**VILLAGE OF DOWNERS GROVE**  
**COUNCIL ACTION SUMMARY**

Motion to Adopt "AN ORDINANCE GRANTING A STORMWATER VARIANCE FOR 5427 BROOKBANK ROAD", as presented.

**AN ORDINANCE GRANTING  
STORMWATER VARIANCE FOR 5427 BROOKBANK ROAD**

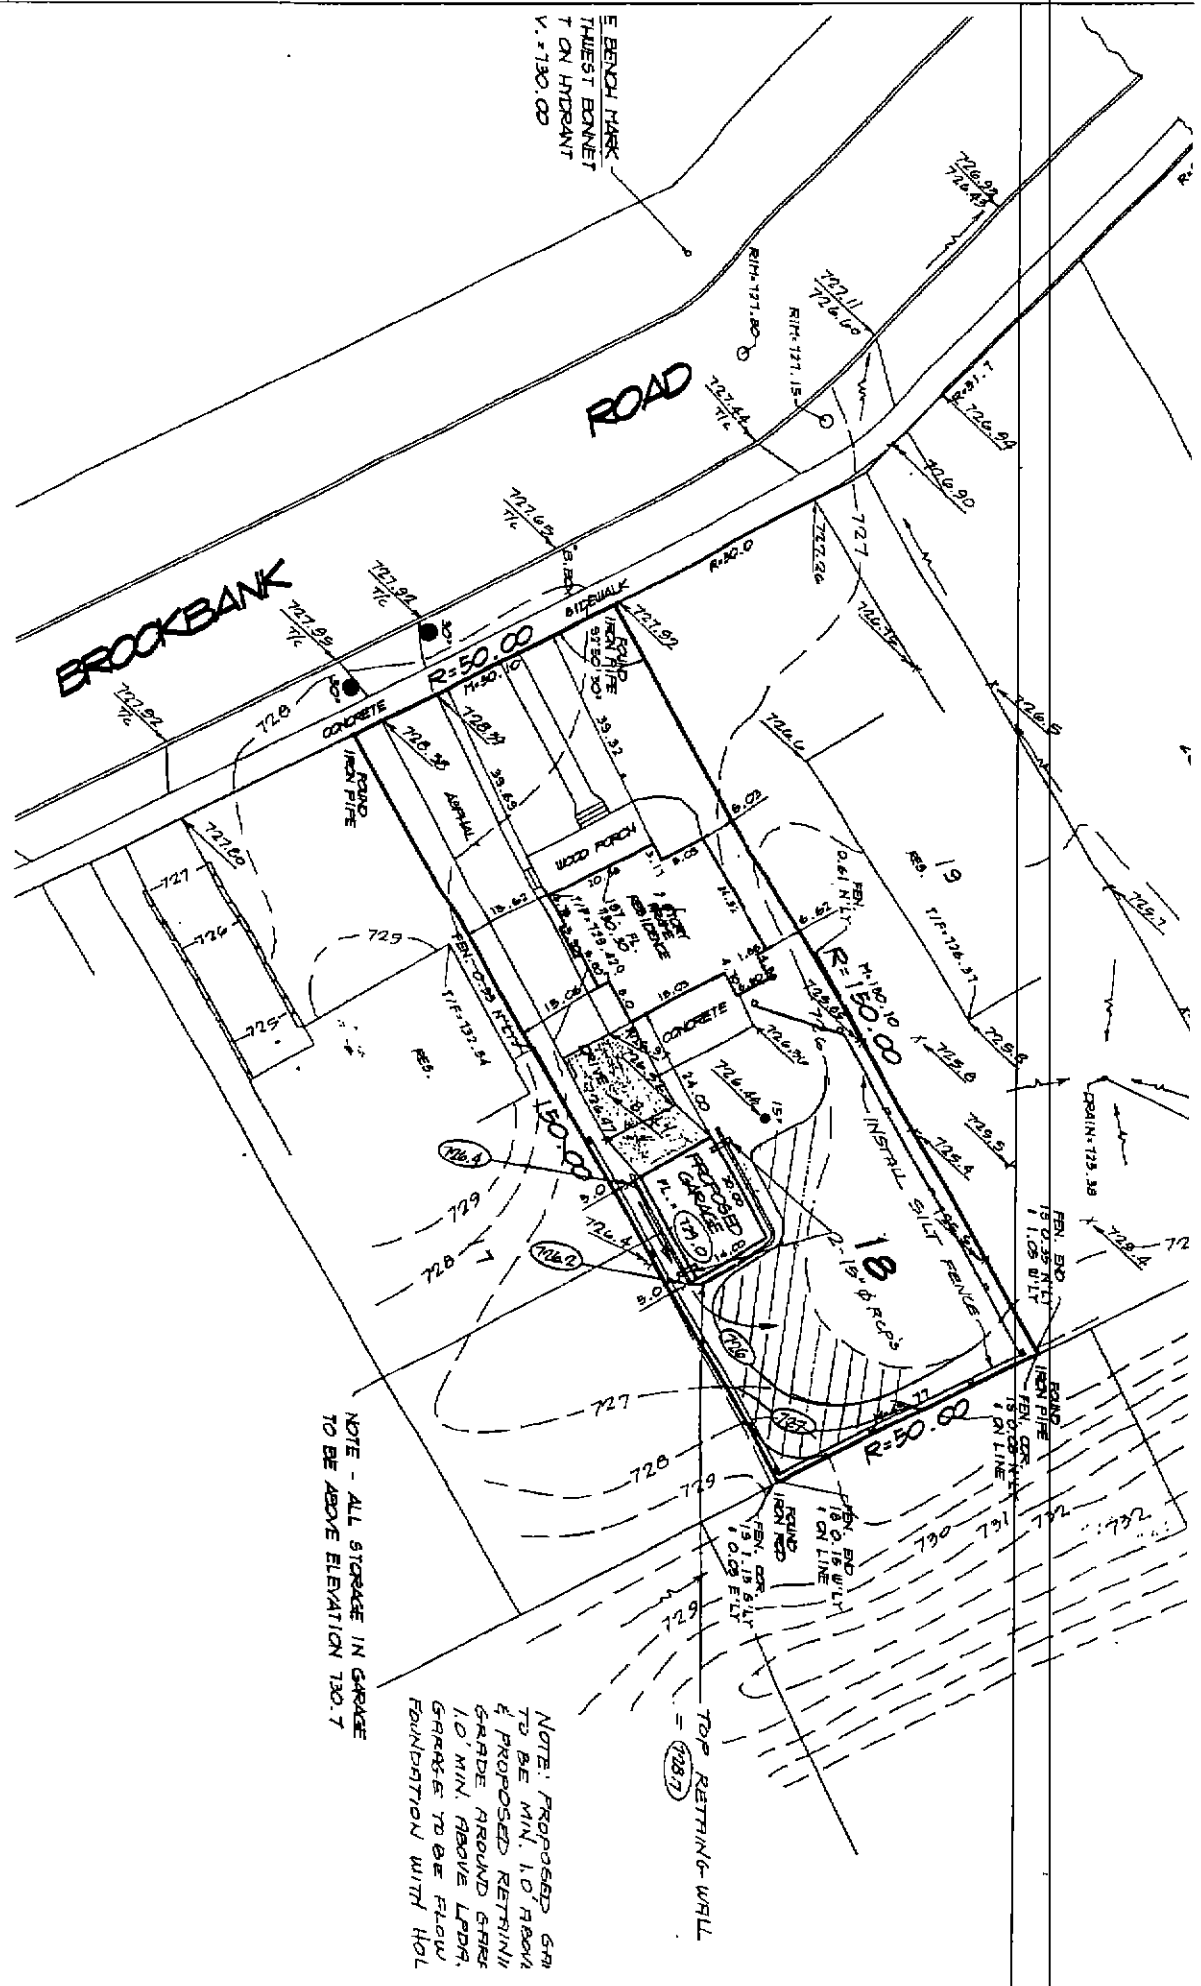
1. That a variance is hereby granted to permit the proposed detached garage lot surface elevation of one (1) foot above the base flood elevation, in lieu of the three (3) foot minimum required per Section 26-62.3 and per Section 26-51.5 of the Stormwater Ordinance.
2. This variance is conditioned upon compliance with all applicable Village Ordinances, including those related to the location and construction of a detached garage.
3. This ordinance shall be in full force and effect from and after its adoption in the manner provided by law.
